APPLICATION NO.	FILING DATE	FIRST NAMED INVENTOR	ATTORNEY DOCKET NO.	CONFIRMATION NO.
10/786,583	02/23/2004	Bret Rasmussen	ACAS-I-1037	4358
25315	7590	07/30/2007	EXAMINER	
BLACK LOWE & GRAHAM, PLLC			STORMER, RUSSELL D	
701 FIFTH AVENUE			ART UNIT	PAPER NUMBER
SUITE 4800.			3617	
SEATTLE, WA 98104

Office Action Summary	Application No.	Applicant(s)
	10/786,583	RASMUSSEN ET AL.
	Examiner	Art Unit
	Russell D. Stormer	3617

Fig. 2A

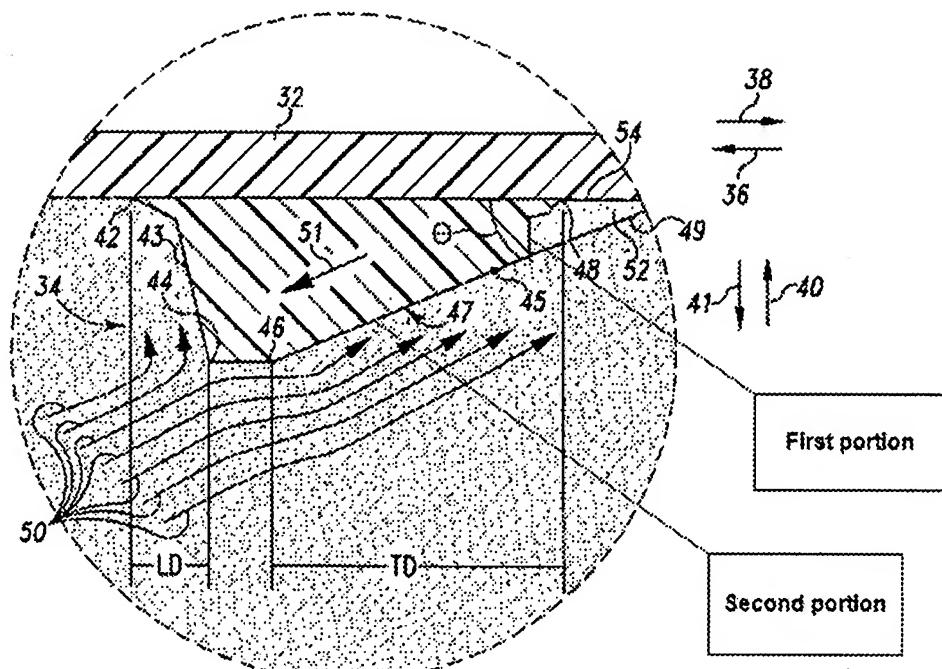
9. Claims 12, 16, 21, 22, and 23 are rejected under 35 U.S.C. 102(b) as being anticipated by Fischer (newly cited).

As shown in figures 2A and 4, the lugs have a lower portion extending away from the track at a first angle, and a second portion extending away at a second angle. See the reproduction of figure 2A below.
